Proposal 36: 8220-00-71, WISC 2022311
Gilman - Medford
CTH B to STH 73 S
STH 64
Taylor County

This is Addendum No. 01, which provides for the following:

ADDENDUM NO. 01

MISCELLANEOUS QUANTITIES
 SHEET 13
 E

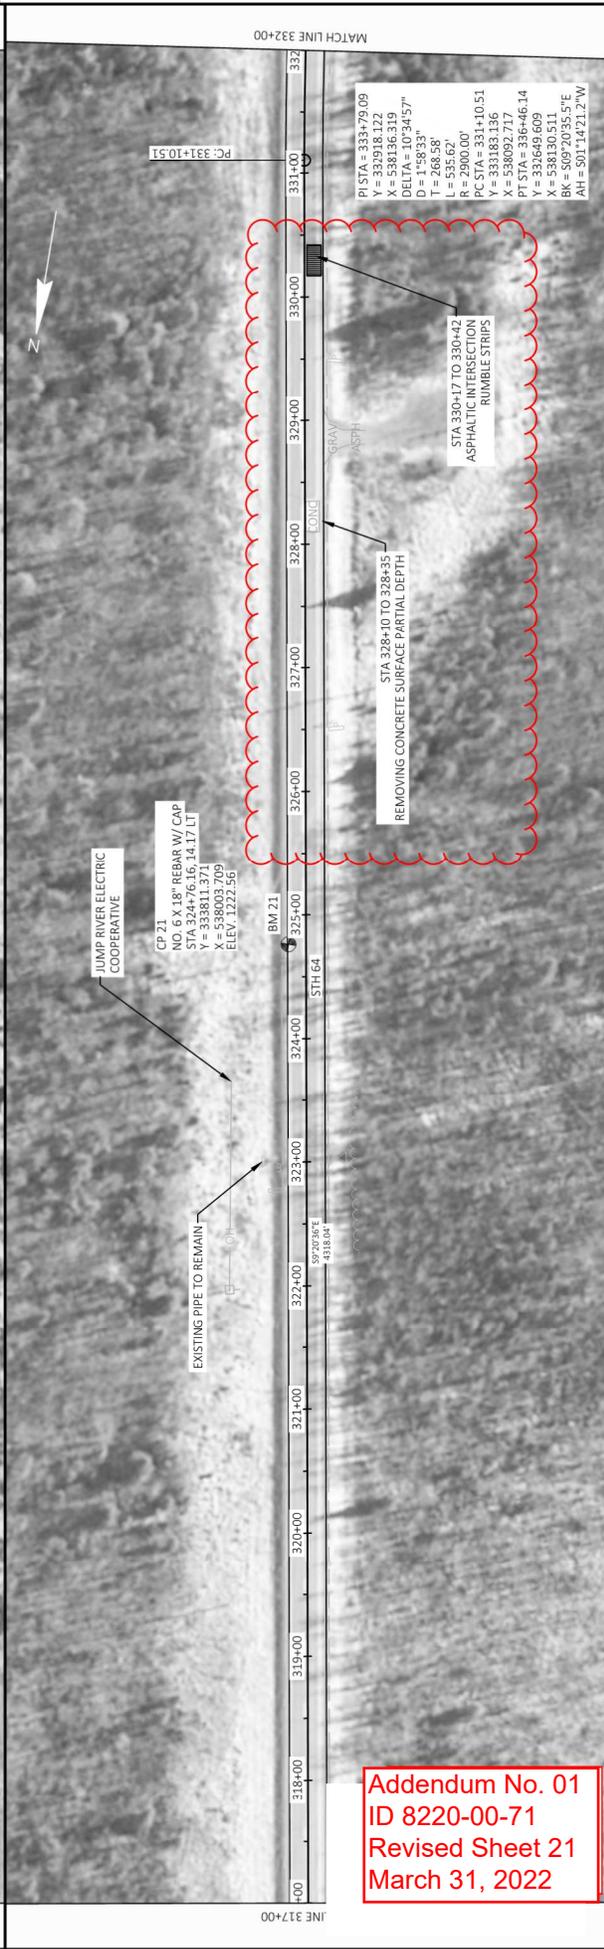
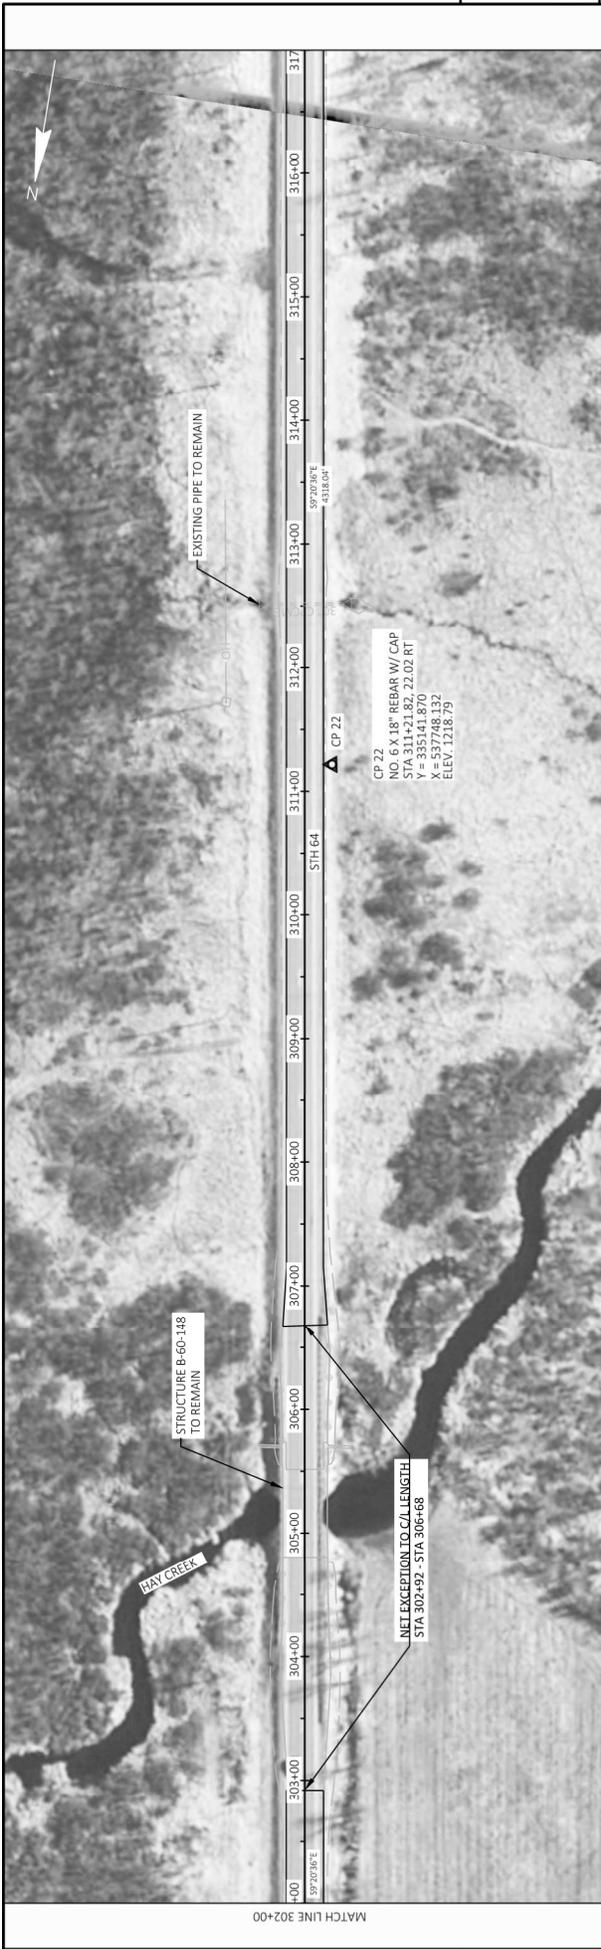
Revised Plan Sheets	
Plan Sheet	Plan Sheet Title (brief description of changes to sheet)
11	Miscellaneous Quantities – Added Item 204.0109.S
13	Miscellaneous Quantities – Item 649.0120 – Added quantity for milled layer
15	Plan STH 64 – Changed to remove concrete rumble strip partial depth
16	Plan STH 64 – Changed to remove concrete rumble strip partial depth and added asphaltic rumble strips
21	Plan STH 64 – Changed to remove concrete rumble strip partial depth and added asphaltic rumble strips
22	Plan STH 64 – Changed to remove concrete rumble strip partial depth and added asphaltic rumble strips

CATEGORY	STATION	TO	STATION	LOCATION	SY
0010	152+27	-	152+52	ML	260
0010	158+00	-	158+25	ML	265
0010	162+57	-	162+81	ML	263
0010	328+10	-	328+35	ML	269
0010	333+08	-	333+33	ML	251
0010	336+57	-	336+81	ML	248
TOTAL 0010					1,556

649.0120		649.0120	TEMPORARY MARKING LINE EPOXY 4-INCH	
0010	99+55	-	115+90	PROJECT	DOUBLE
0010	115+90	-	126+80	PROJECT	BOTH
0010	126+80	-	132+60	PROJECT	3 KIP
0010	132+50	-	153+60	PROJECT	4 KIP
0010	153+50	-	161+40	PROJECT	5 KIP
0010	161+40	-	175+50	PROJECT	BOTH
0010	175+50	-	179+41	PROJECT	3 KIP
0010	180+80	-	207+15	PROJECT	4 KIP
0010	207+15	-	214+20	PROJECT	4 KIP
0010	214+20	-	217+80	PROJECT	5 KIP
0010	217+80	-	224+60	PROJECT	BOTH
0010	224+50	-	250+00	PROJECT	3 KIP
0010	250+00	-	270+40	PROJECT	4 KIP
0010	270+40	-	302+92	PROJECT	5 KIPS
0010	306+58	-	322+65	PROJECT	3 KIPS
0010	322+55	-	339+66	PROJECT	21.26
0010	99+55	-	339+66	PROJECT	1.920
0010	99+55	-	339+66	PROJECT	LOWER LAYER
	TOTAL 0010		18,461		22.301

ASPHALTIC RUMBLE STRIPS AT INTERSECTION

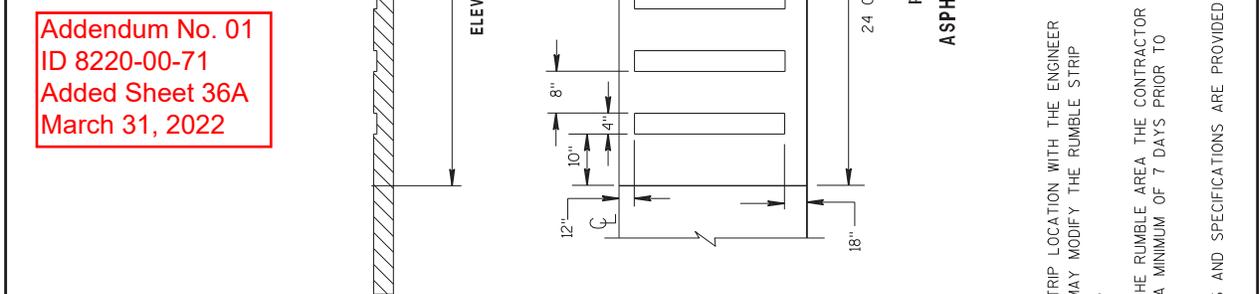
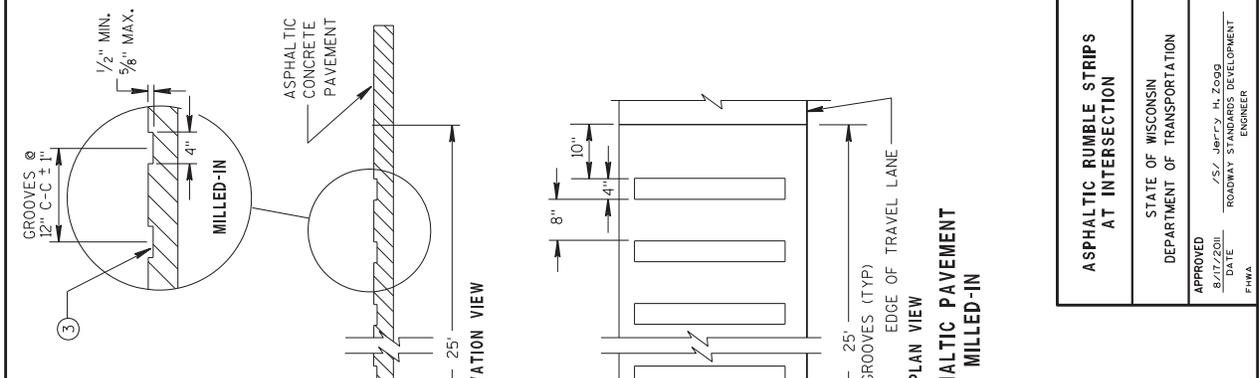
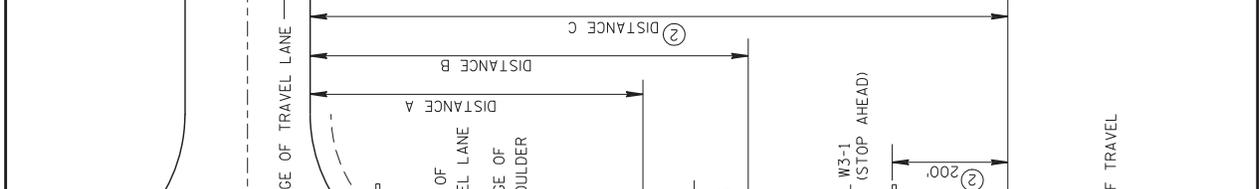
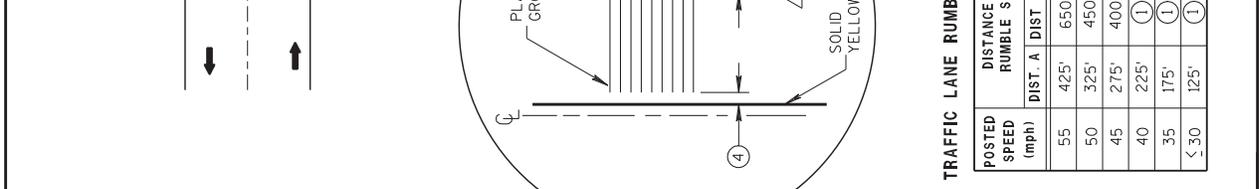
Added Plan Sheets	
Plan Sheet	Plan Sheet Title (brief description of why sheet was added)
36A	SDD - Asphaltic Rumble Strips at Intersection – New bid item

- 1 ELIMINATE THE MIDDLE SET OF RUMBLE STRIPS.
- 2 LOCATE RUMBLE STRIP 200' IN ADVANCE OF W3-1 SIGN AS SHOWN. IF W3-1 IS NOT IN PLACE, USE DISTANCE C.
- 3 TYPICAL VERTICAL VARIATION BETWEEN PEAKS AND VALLEYS WITHIN THE CUT APPROXIMATELY 1/16"
- 4 12" CLEAR BETWEEN THE SOLID YELLOW LINE AND THE EDGE OF THE RUMBLE.
